APPRAISAL OF SEARSPORT DEEPENING PROJECT

Prepared for Isleboro Island Trust

May 9, 2014

Dawson & Associates has reviewed the U.S. Army Corps of Engineers' April 2013 Draft Feasibility Report & Environmental Assessment for enlarging the Federal navigation channel serving Searsport, Maine in order to determine whether the proposed channel enlargement is justified. We also reviewed other publicly available and pertinent documents.

Figure 3

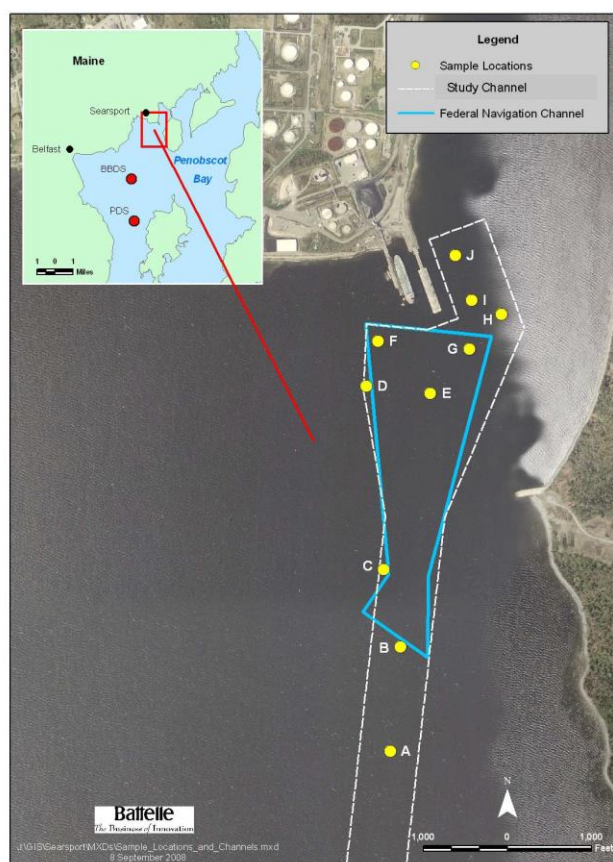
The Corps' April 2013 environmental assessment acknowledges the presence of mercury in project sediment:

On April 30 and May 1, 2008, 10 sediment core samples were collected in Searsport Harbor within the proposed project area. The four composite sediment and six reference site samples were also analyzed for eight metals: arsenic (As), cadmium (Cd), chromium (Cr), copper (Cu), lead (Pb), mercury (Hg), nickel (Ni), and zinc (Zn) [p 20] ... Metals were detected in all harbor composite and reference site samples (Table EA-9). Concentrations of most metals were generally below the sediment quality guidelines, especially at harbor locations (Table EA-9). For example, metals concentrations were below the sediment quality guidelines in all harbor composites except for chromium in harbor composite ABC and nickel in harbor composites ABC, DF and EGHI. Chromium and nickel concentrations were also above the sediment quality guidelines in the reference site samples, as were mercury concentrations (Table EA-9).³

There is no further discussion of mercury contamination in the Corps report.

Figure 4

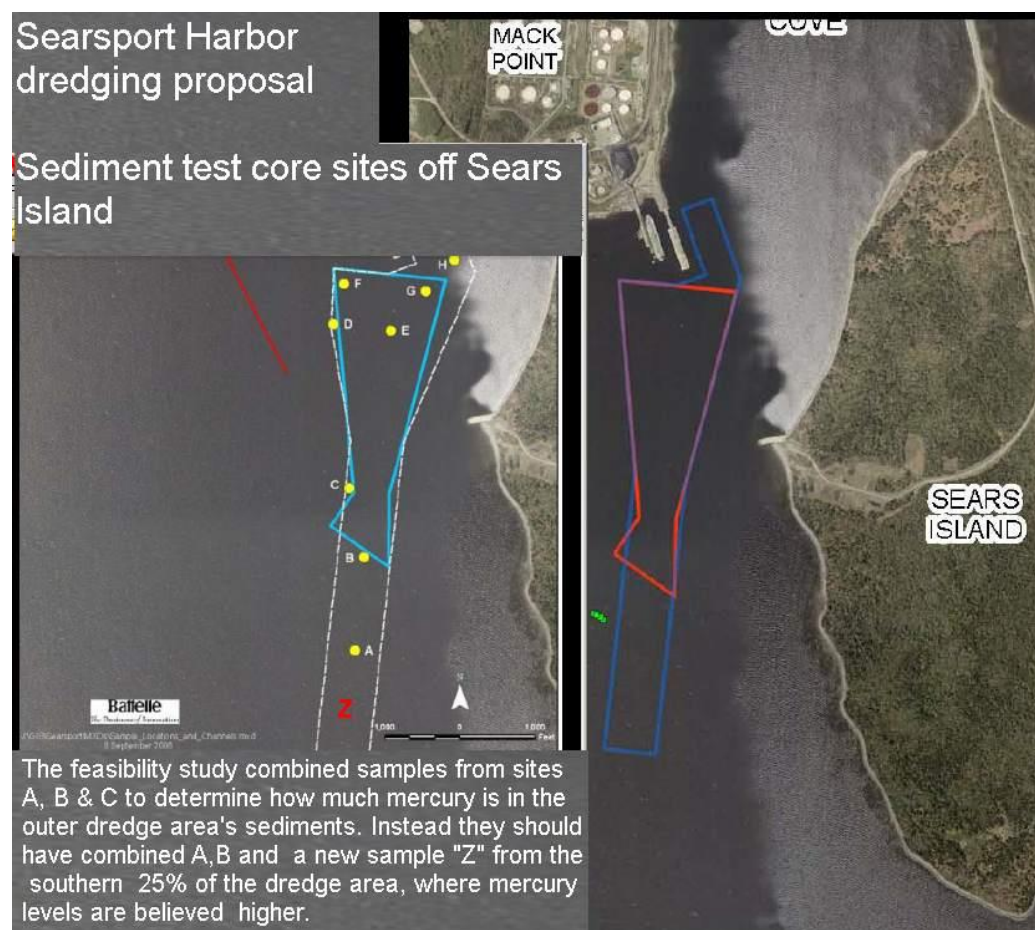
Sampling stopped short of the southern end of the proposed project limits which would be closer to the source (see figure 4). In addition, the outline of the project only shows the limits of the 40-foot depth and not the surrounding extended areas that have to be dredged to provide a stable slope. The graphic shows the entrance channel being 650 feet. However, to account for the 1H:3V slope the channel disturbance would extend 15 feet or further on either side depending on the natural depth contour. The sampling does not account for that.

Given concerns expressed at the April 8, 2014 hearing in Belfast, Maine and the potential for Mercury⁵ contamination, it is recommended that the Corps of Engineers conduct additional analysis and coordination as part of its feasibility report process before making a final decision on the project.

Figure 5

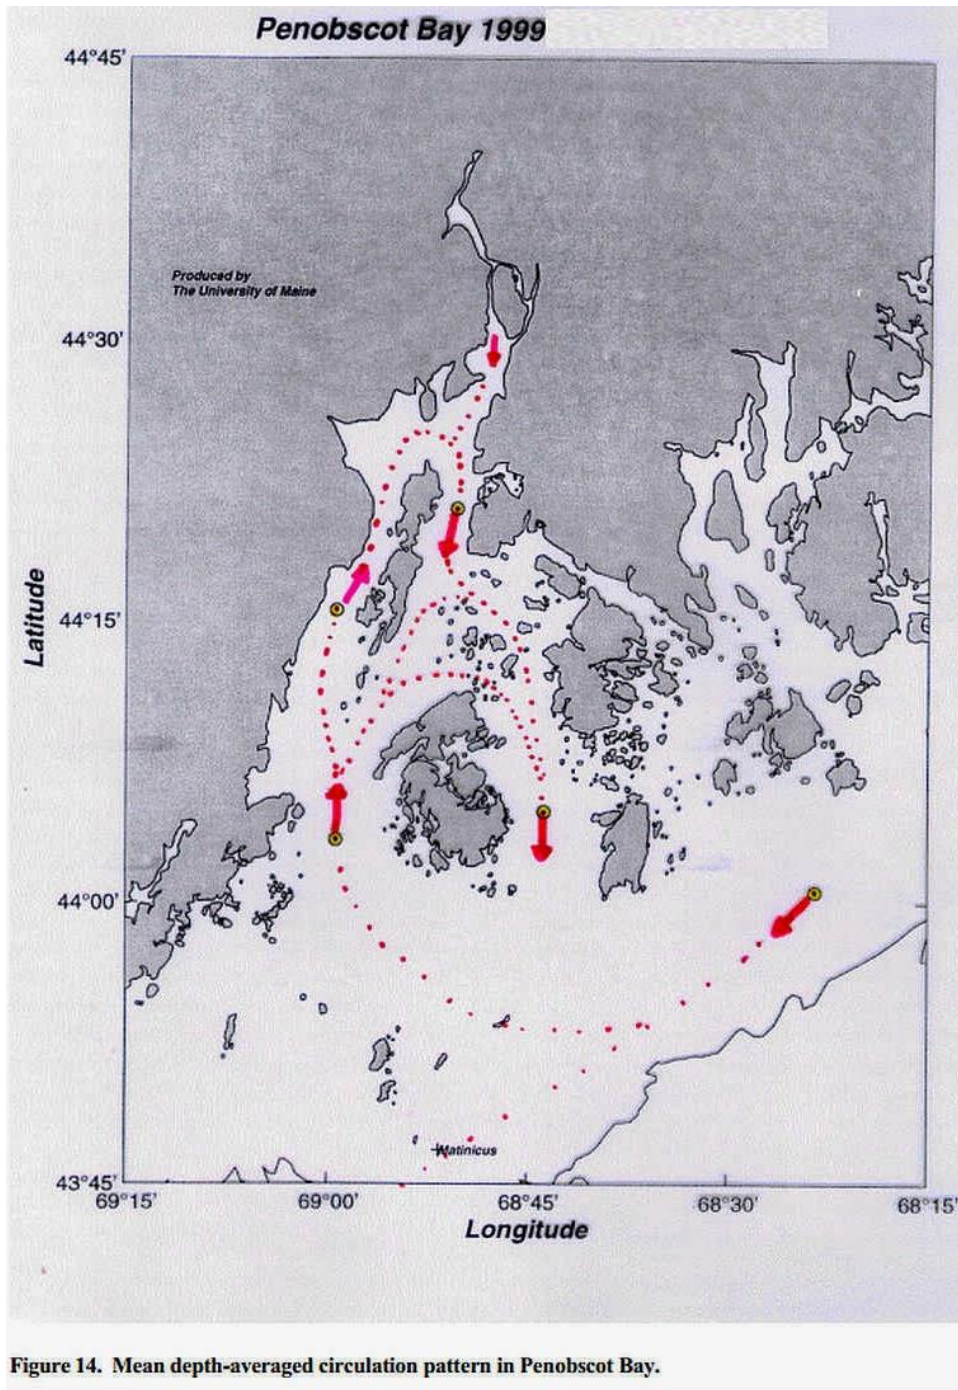
While Sears Island and the causeway appear to direct the Penobscot River mercury laden flows to the east of the harbor, tidal influenced circulation indicates that sediments could be introduced into the project area (see figure 5).

The issue appears to be the placement of potentially polluted sediment. If mercury from within the project exceeds the thresholds allowable for open water disposal as presented in the Corps and EPA's *Regional Implementation Manual for the Evaluation of Dredged Material Proposed for Disposal in New England Waters*, April 2004, a far more expensive disposal would be required.
